Official Plan & Zoning By-law Amendment Applications

Applicant: Adi Development Group Inc.
Address: 4853 Thomas Alton Blvd.
Files: 505-05/15 & 520-08/15
Date: July 11, 2016

3. Tall Building Design

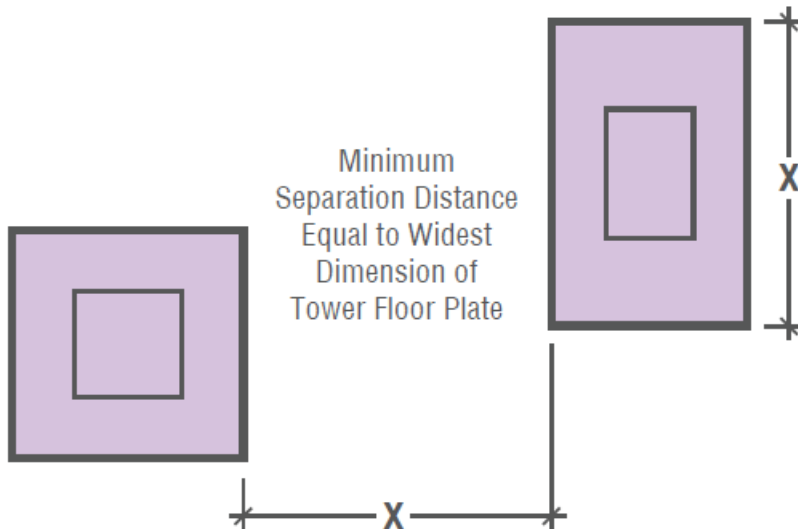
- Less than 750m²
- Proposed is a floor plate of 781m²
- Staff recommends: max. 750 m²

ii. Tower Separation

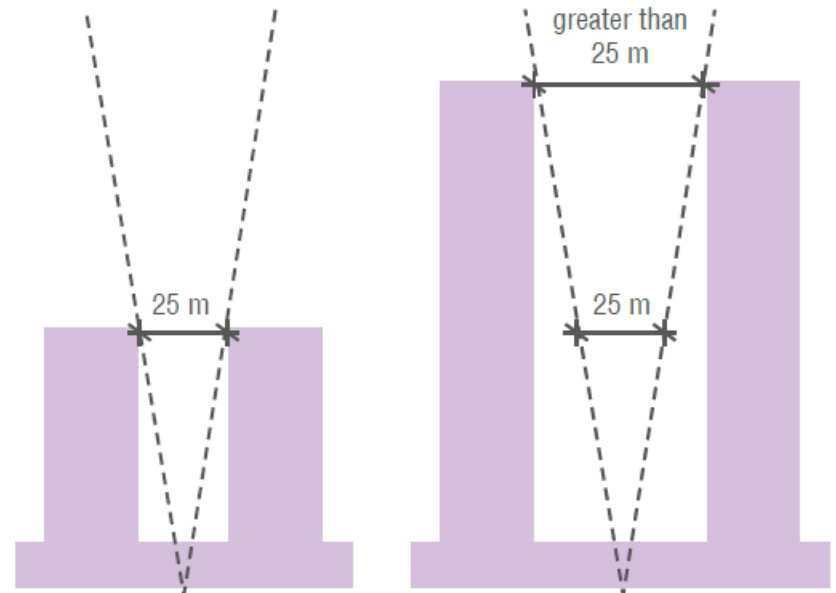
- Provide separation between towers of 25 m or greater
- Proposed is 21.5 m
- Staff recommends: min. 25 m

iii. Tower Placement

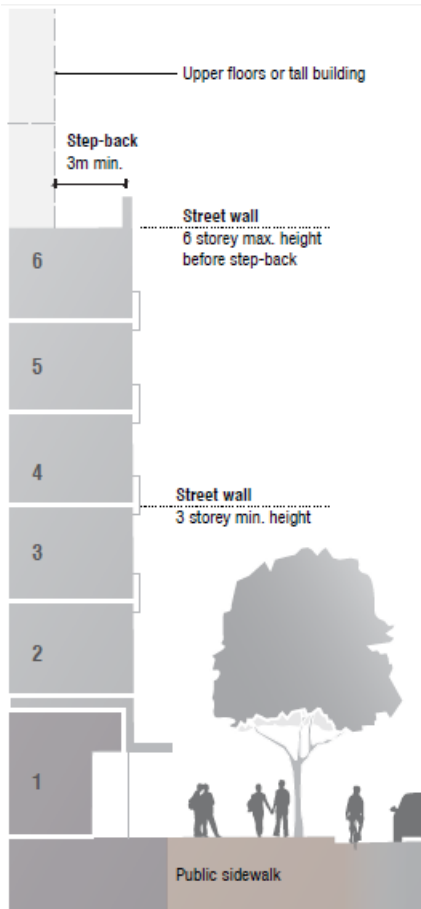
- Staff recommends: min. 3 m step back from podium

4. Stacked Townhouse Building Design;

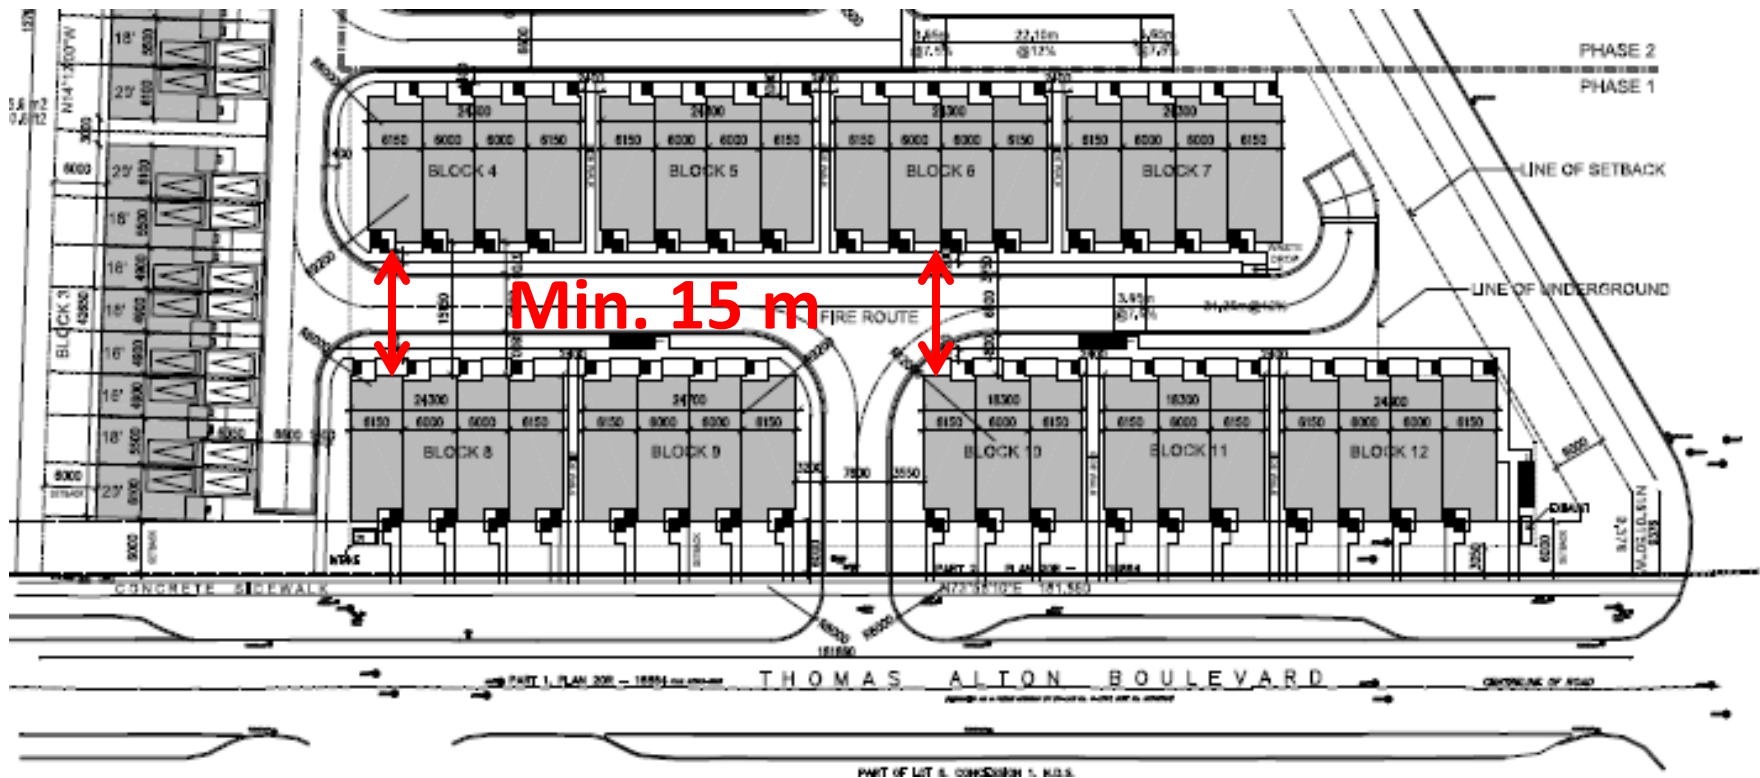
- Proposed is 15.15 m
- Staff recommends: min. 15 m

4. Stacked Townhouse Building Design;

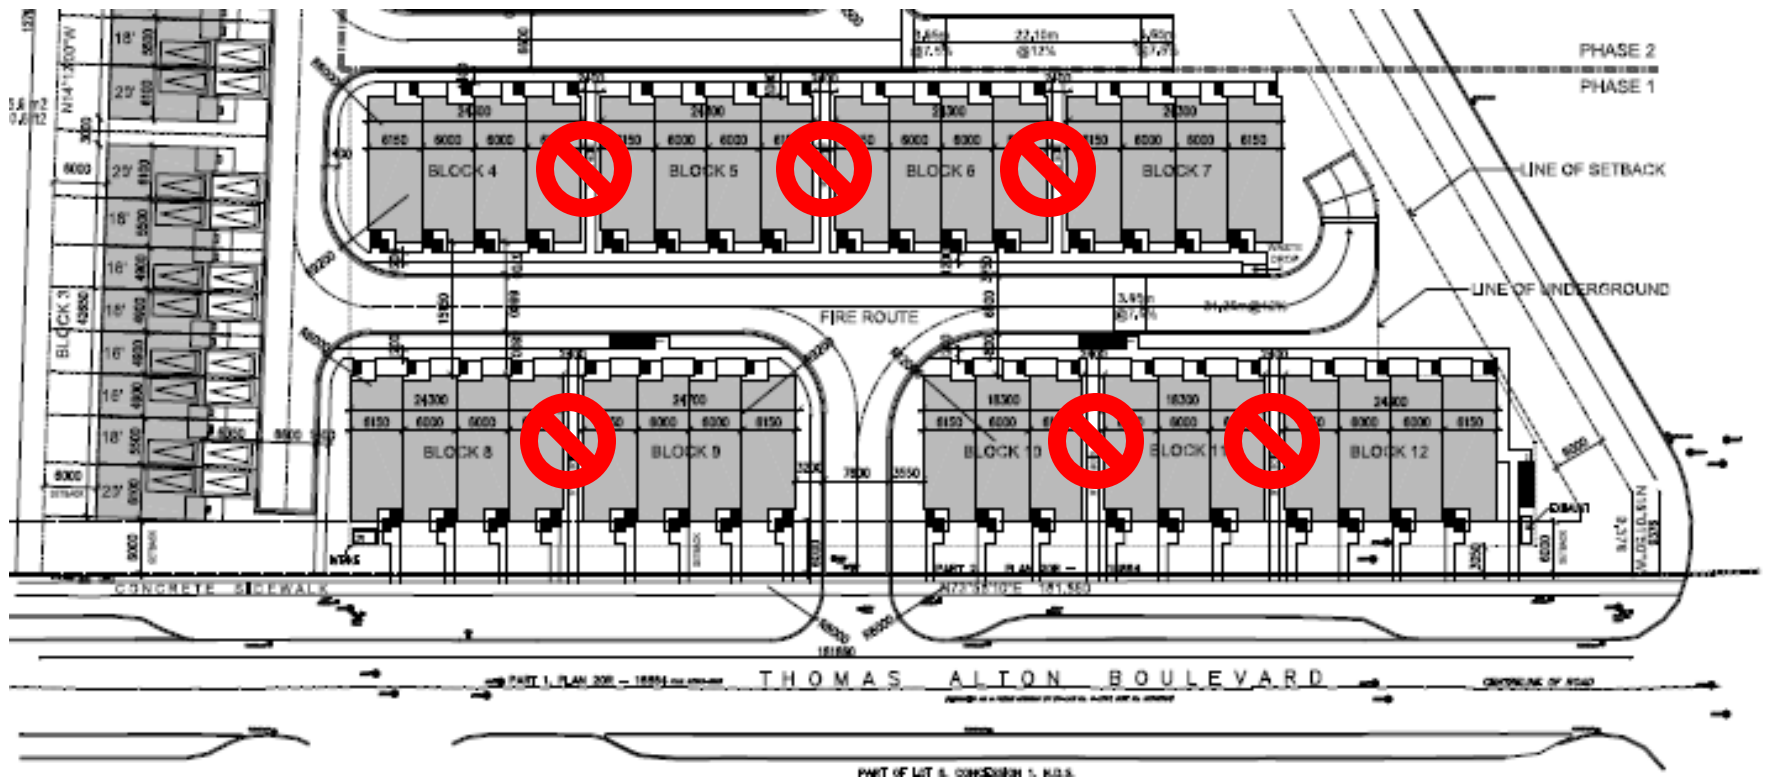
- Proposed are 6 narrow pedestrian walkways
- Staff recommends: 1 mid-site connection
